SUNDRY NOTICES AND REPORTS ON WELLS
Do not use this form for proposals to drill or to re-enter an abandoned well. Use Form 3160-3 (APD) for such proposals.

| 2. Name of Operator Nordstrand Engineering Inc. | | 7 If Unit or CA/Agreement, Name and/or No West Henshaw Premier Unit Trk 6 |
| 3a. Address 3229 D'Amico St. # 2200 Houston, TX 77019 | 3b. Phone No. (include area code) 713 520 1555 | 8 Well Name and No W Henshaw Premier Unit Trk6 #1 |

RE: Plugging and Abandonment Requirements, Conditions of Approval

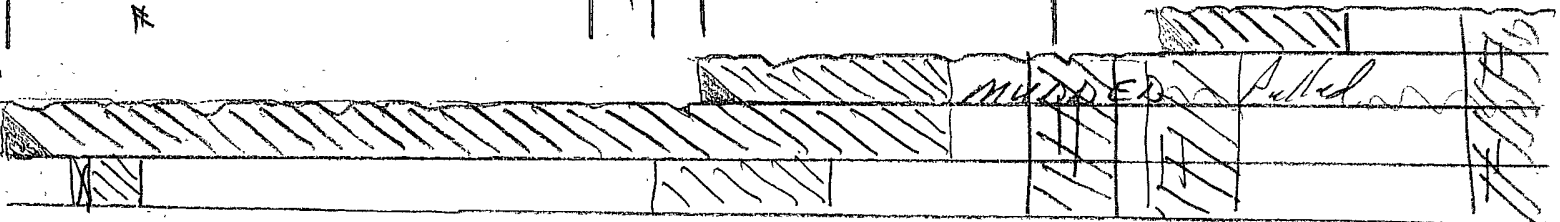
* See attached COA's
Records indicate 8 5/8 pulled

Step 3. Spot 30 sx cement from 2205'-2085' (covers the 8-5/8" shoe and top of Queen formation).

Step 4. Perforate 5-1/2" and 8-5/8" casings @ 1250', squeeze with adequate cement to fill 110' in/out of both casings (covers the base of salt). WOC and tag no lower than 1140'.

Step 5. Perforate 5-1/2" and 8-5/8" casings @ 475', squeeze with adequate cement to fill 140' in/out of both casings (covers the top of salt and the 10-3/4" shoe). WOC and tag no lower than 335'.

Step 6. Perforate 5-1/2", 8-5/8" and 10-3/4" casings @ 60', circulate cement to fill all casings to surface. Cut off well head and fill annulus as needed.
